CITY OF ALBUQUERQUE

Re: Sandia Acrobatic Gymnastics Academy
3400 Candelaria Rd. NE
Traffic Circulation Layout
Architect's Stamp 10-18-17 (H16D152)

DRAINAGE AND TRANSPORTATION INFORMATION SHEET (REV 09/2015)

TRAFFIC CIRCULATION LAYOUT for EXISTING CONDITIONS

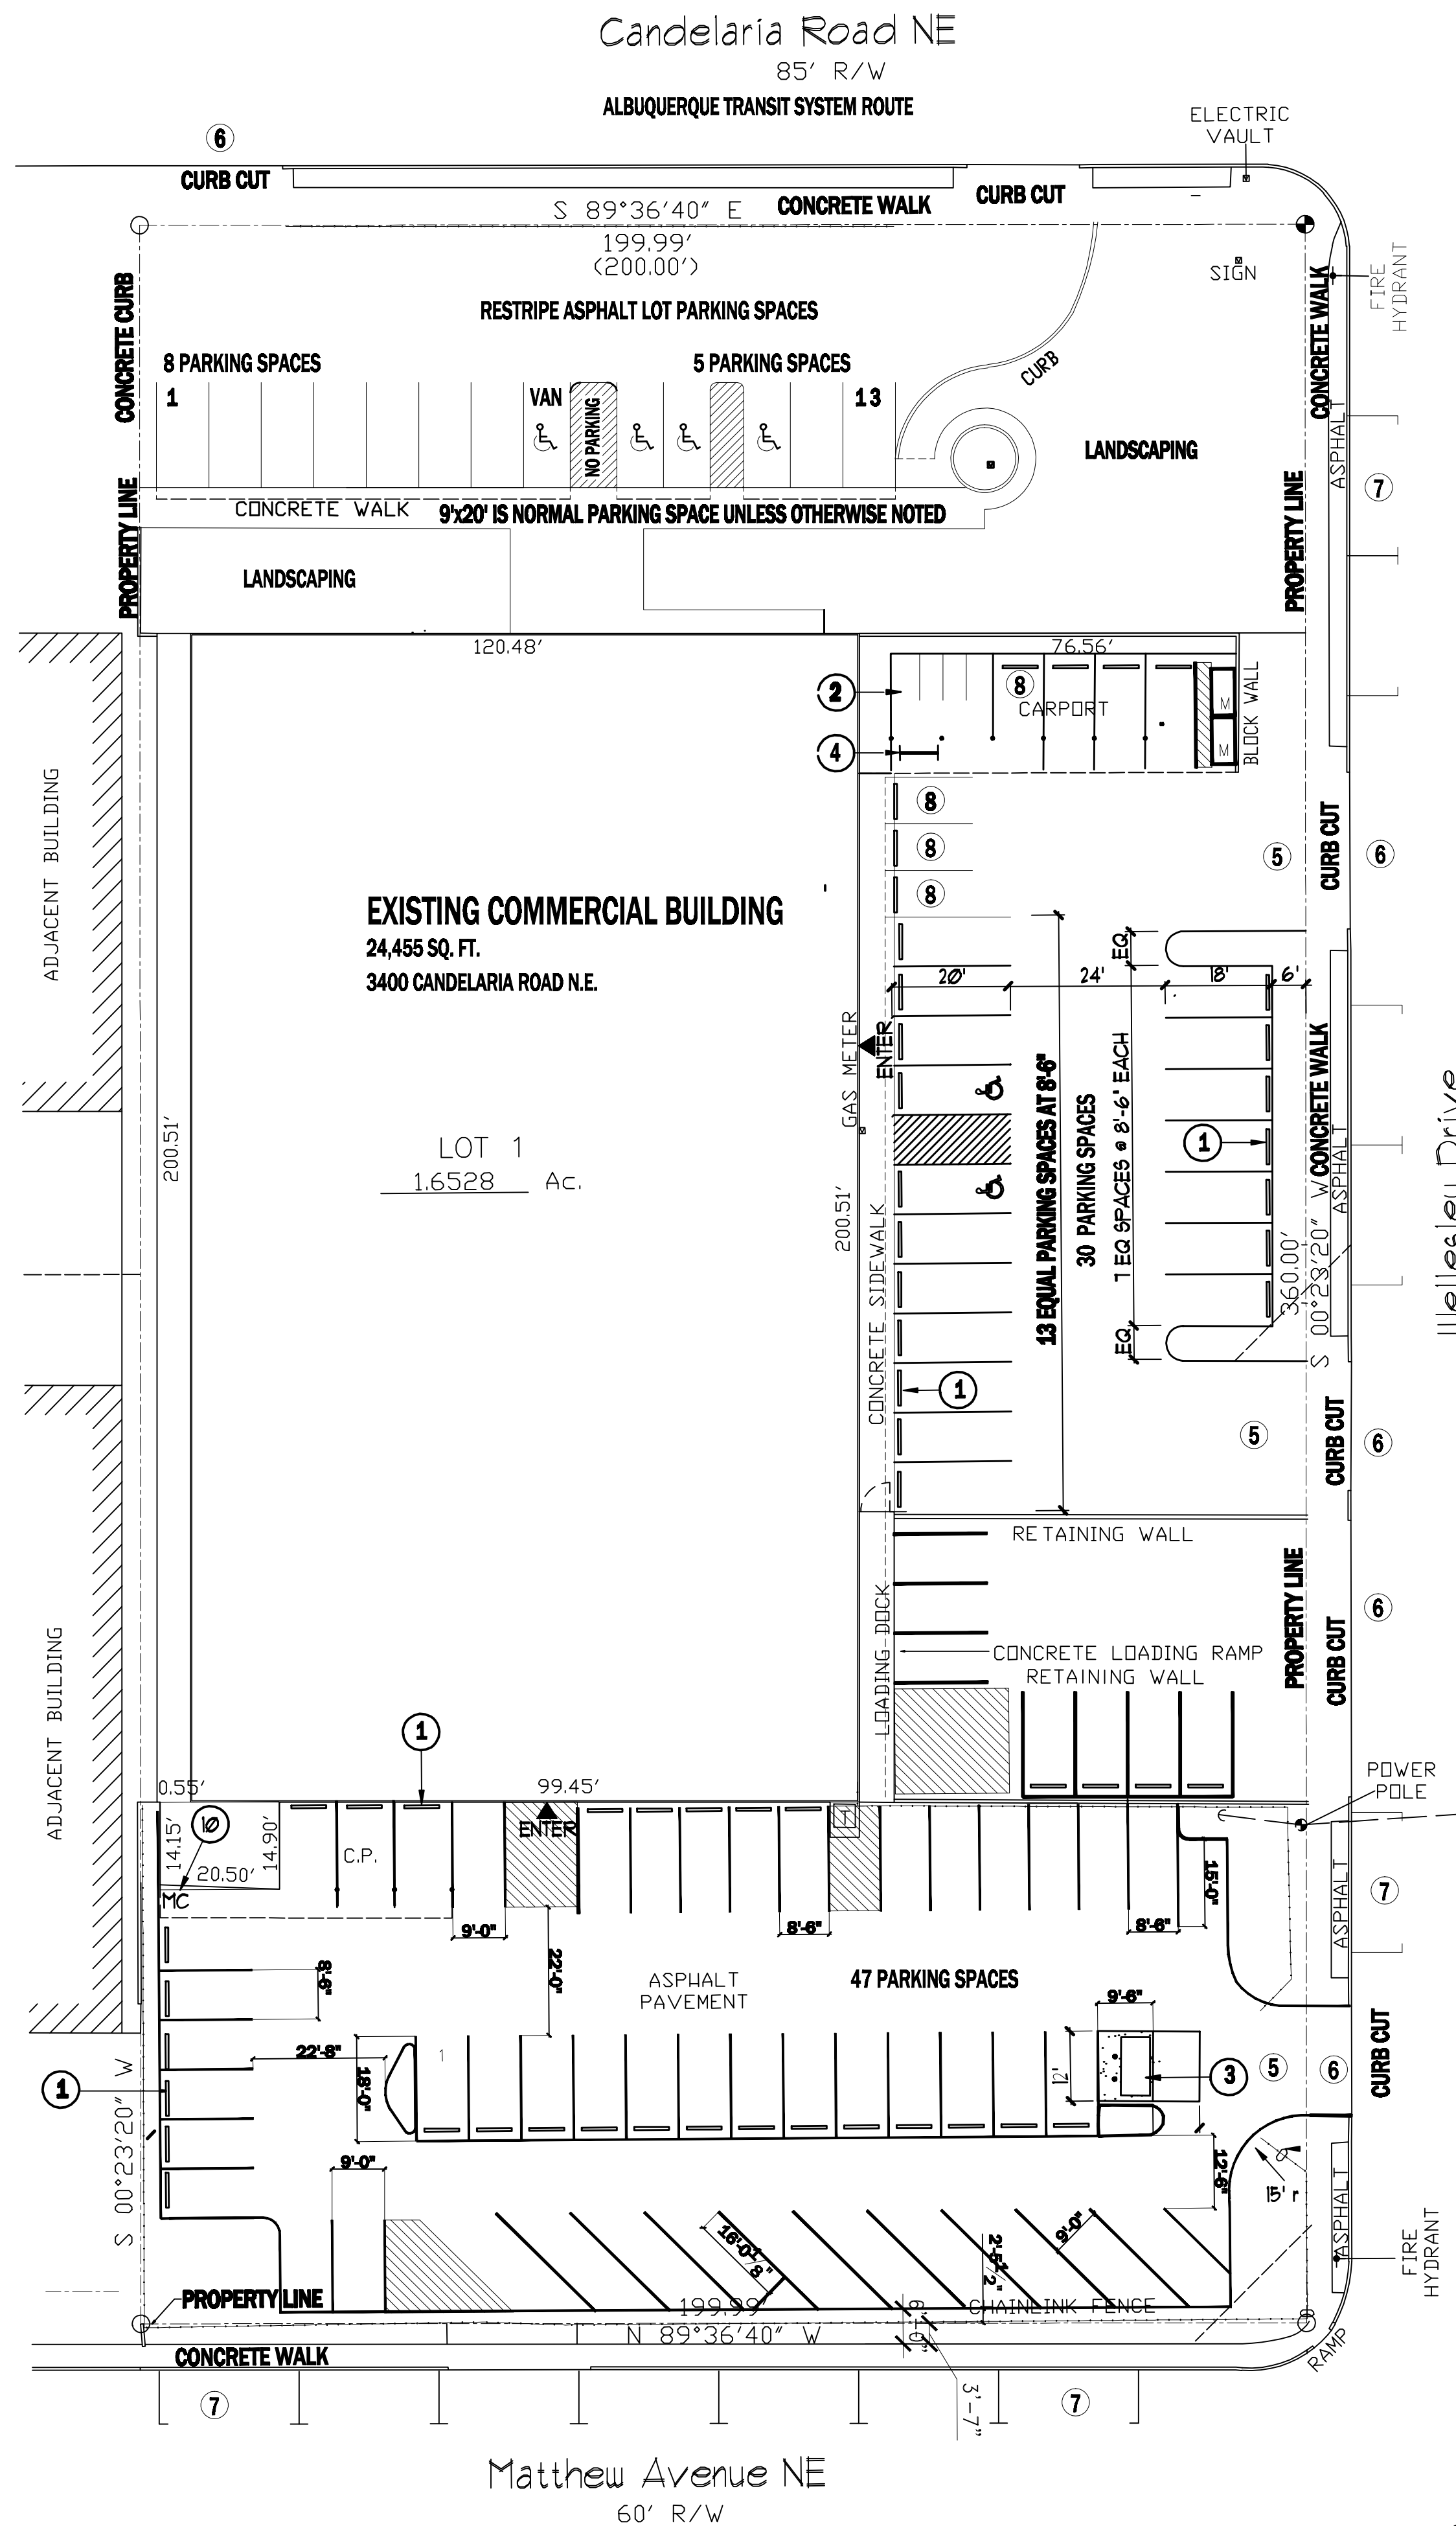
1. Please show a vicinity map showing the location of the development in relation to streets and well known landmarks.
2. Label the compact parking spaces by placing the words "**COMPACT**" on the pavement of each space.

3. Dimension the widths on all drive entrances and parking access aisles some dimensions are not shown.
4. List radii for all curves shown; for passenger vehicles, the minimum end island radius for passenger vehicles is 15 ft. Radius for delivery trucks, fire trucks, etc. is 25 ft. or larger.

5. Per DPM, a 6 ft. wide ADA accessible pedestrian pathway is required from the HC parking stall access aisles to the building entrances. Please clearly show this pathway and provide details. Also show the ADA ramps from the ADA access aisles to the building entrances.

6. Please provide the locations of the ADA signs for the ADA parking spaces.
7. Please define "M" that located on the northeast side of the building.
8. On-Street parking credit to fulfill zoning's parking requirement must be requested and approved by the Traffic Engineer, Racquel Michel prior to TCL approval. The application requires at least 45 working days. On-street parking credit is based on available parking along public right-of-ways fronting the property. The business will only be granted 50% credit for available street parking.

9. Unused curb cuts must be replaced with sidewalk and curb & gutter. A build note must be provided referring to the appropriate City Standard drawing.

10. Motorcycle parking spaces shall be designated by its own conspicuously posted upright sign, either free-standing or wall mounted per the zoning code.
11. The angled parking on the south side of the site looks too small, please follow the DPM for angled parking and provide the angle of the parking space.
12. One-way vehicular paths require pavement directional signage and a posted **"Do Not Enter"** sign at the point of egress. Please show detail and location of posted signs. The access aisles for the parking on the south of the site are too small for two way traffic.
13. Service vehicle and/or refuse vehicle maneuvering must be contained on-site; provide a copy of refuse approval.
